Detroit
Edison

August 18, 1982
EF2 - 59,061

Subject: Evaluation of the Enrico Fermi-2
Drywell-to-Wetwell Vacuum Breakers

FIGURE 1
 GPE 18" VALVE GEOMETRY
 (GPE TYPE LD-240-208)

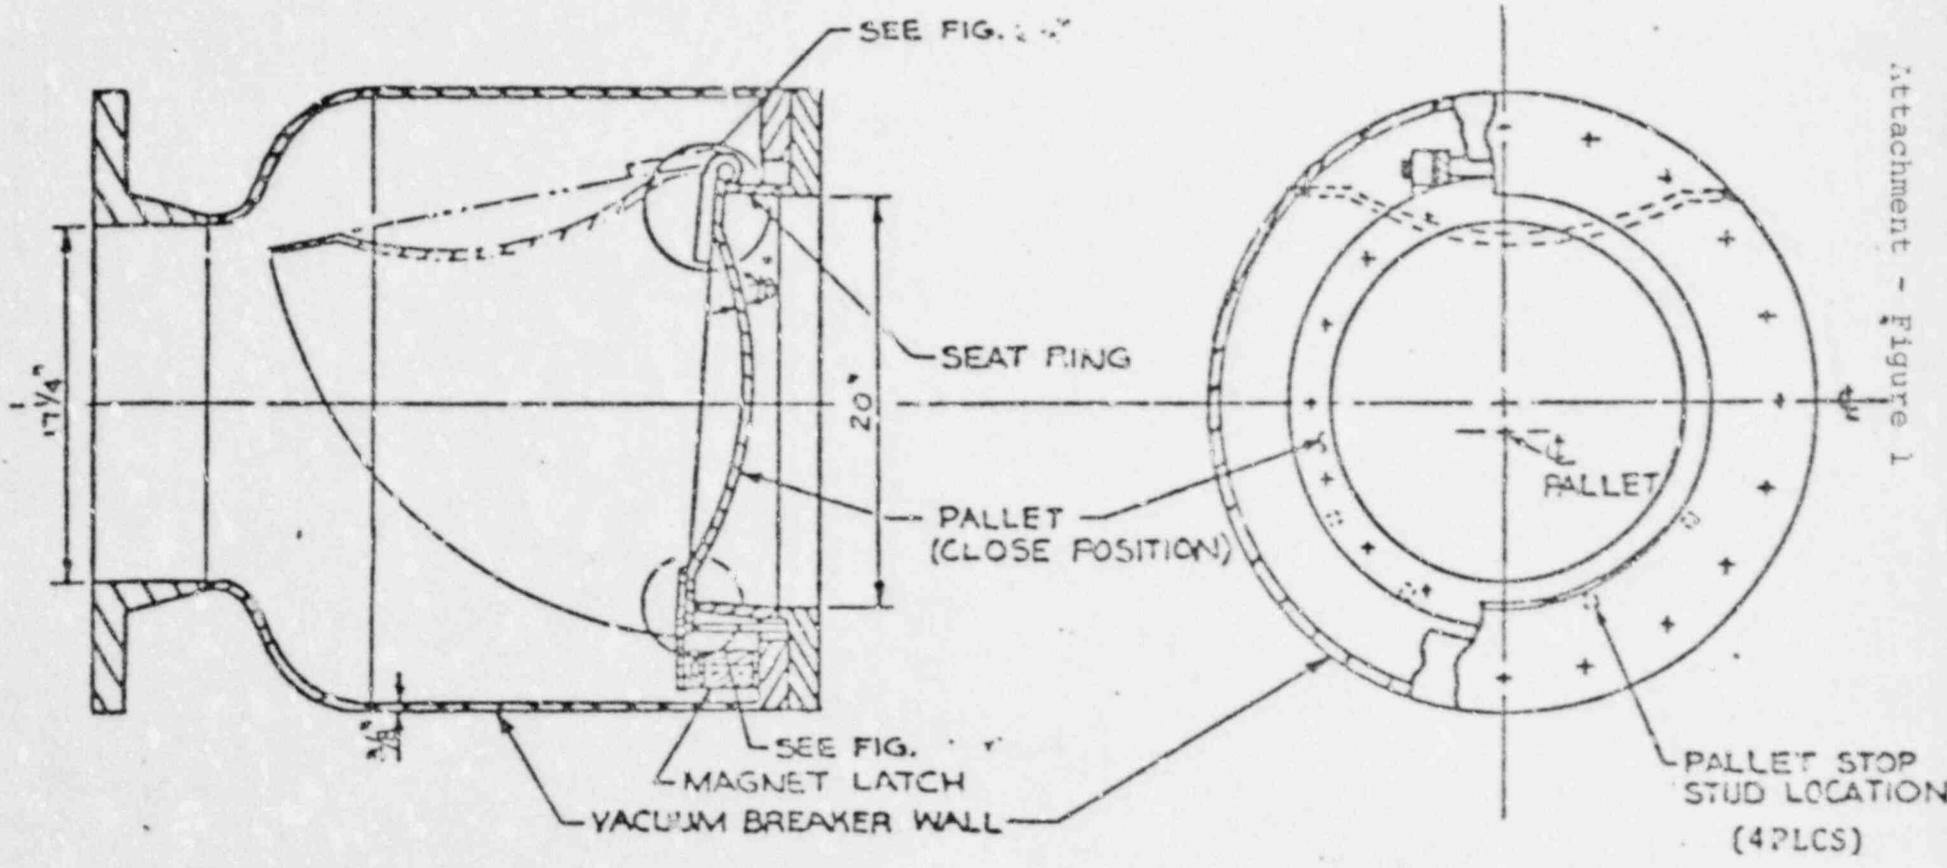
Fermi-2 has twelve (12) GPE 18" O.D. drywell-to-wetwell vacuum breaker valves. The general arrangement of the GPE valve design has been provided in the attached Figure #1. The vacuum breakers would open after a postulated LOCA to vent non-condensables from the wetwell airspace into the drywell when the steam in the drywell begins to condense. The size and number of vacuum breakers has been determined to ensure that the Fermi-2 drywell vacuum conditions do not exceed the external pressure design limit (-2 psig) for the structure. Section 6.2.1.2.1.10 of the Fermi-2 FSAR provides a more detailed discussion of the vacuum breakers.

The impact velocities predicted for the limiting design loading conditions were utilized in dynamic structural impact analyses to determine the stresses in the valve components. The analytical model developed for the analysis treated the moving parts of the valve as a single-degree-of-freedom system rotating about a pivot point at the shaft location. The results of the structural analyses predicted that several valve components would exceed the ASME code limits. These components were the pallet, hinge arm, hinge arm stud and the shaft. The results of additional analyses

showed that utilizing available higher strength materials for these components would provide the necessary corrective action. The maximum allowable impact velocity corresponding to the ASME code allowable limit for Service Level A, for the higher strength materials, was determined to be 9.28 rad/sec. Therefore, corrective action instituted by a repair program to replace the appropriate valve components with ones made from higher strength materials would restore the valve to within ASME allowable limits for the predicted design impact velocity of 7.6 rad/sec.

Accordingly, Detroit Edison is currently proceeding with a program to replace the components that exceed the ASME code limits. The attached Table 1 lists the components, the existing materials, and higher strength materials which will be utilized in manufacturing the replacement parts.

<u>Component</u>	<u>Existing Material Specification</u>	<u>Replacement Material Specification</u>
Pallet	SA-516 GR70	SA-564
Hinge Arm	SA-516 GR70	SA-564
Hinge Arm Stud	SA-320-B8	SA-564
Shaft	SA-320-B8	SA-564
